# Access Compliance Report

## Public Rights-of-Way

### (Curb Ramps)

Intersection ID: 7900	Main Street: EDGERTON_DR	Cross Street: SNOW_WHITE_LN	Location: SE
ADA ID: 978C309DCF9F	Ramp Type: Perp	Initial Pass/Fail: Fail	Overall Compliance: No
Severity Score: 12.5			
Codes/Mitigation Info/Possible Solution		Field Measurements/Component Compliance

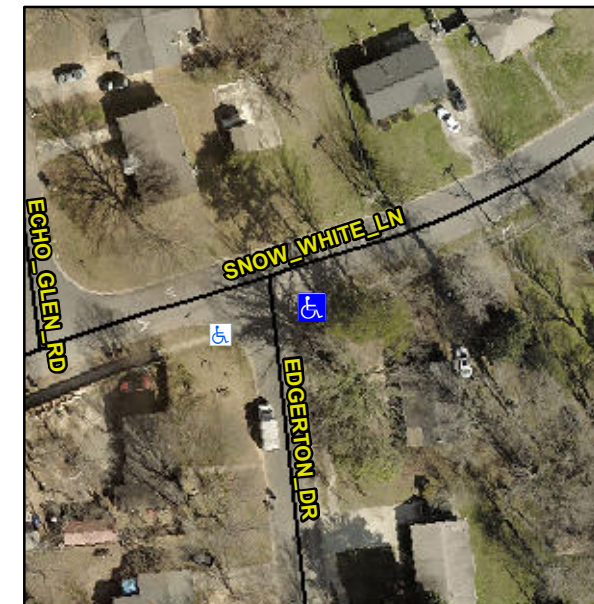
**Not Found, R304.2.2**

Compliance	Description	Data	Compliance	Description	Data
N/A	Ramp Length (in)	20.5	No	Ramp Slope (%)	9.7
Yes	Ramp Width (in)	48.0	Yes	Ramp XSlope (%)	2.0
N/A	Flare Type LT	N/A	N/A	Flare Type RT	N/A
N/A	Flare Slope LT (%)	N/A	N/A	Flare Slope RT (%)	N/A
N/A	Flare Traversable LT?	N/A	N/A	Flare Traversable RT?	N/A
N/A	Landing Length (in)	N/A	N/A	DWS Provided?	N/A
N/A	Landing Width (in)	N/A	N/A	DWS Contrast?	N/A
N/A	Landing Slope (%)	N/A	N/A	DWS Length (in)	N/A
N/A	Landing X Slope (%)	N/A	N/A	DWS Full Width?	N/A
N/A	Landing Curb? (Y/N)	N/A	N/A	DWS Offset (in)	N/A
N/A	Shared Landing?	N/A			
N/A	Gutter Ponding?	Yes	N/A	Gutter Slope (%)	N/A
N/A	Gutter Lip Ht (in)	N/A	N/A	Gutter X Slope (%)	N/A
N/A	Painted X Walk1?	No	N/A	Painted X Walk2?	N/A
	X Walk 1 Direction	To W		X Walk 2 Direction	N/A
N/A	X Walk 1 Width (in)	N/A	N/A	X Walk 2 Width (in)	N/A
	X Walk 1 Slope (%)	3.8		X Walk 2 Slope (%)	N/A
	X Walk 1 X Slope (%)	2.8		X Walk 2 X Slope (%)	N/A

**Remove & Replace Entire Ramp.**
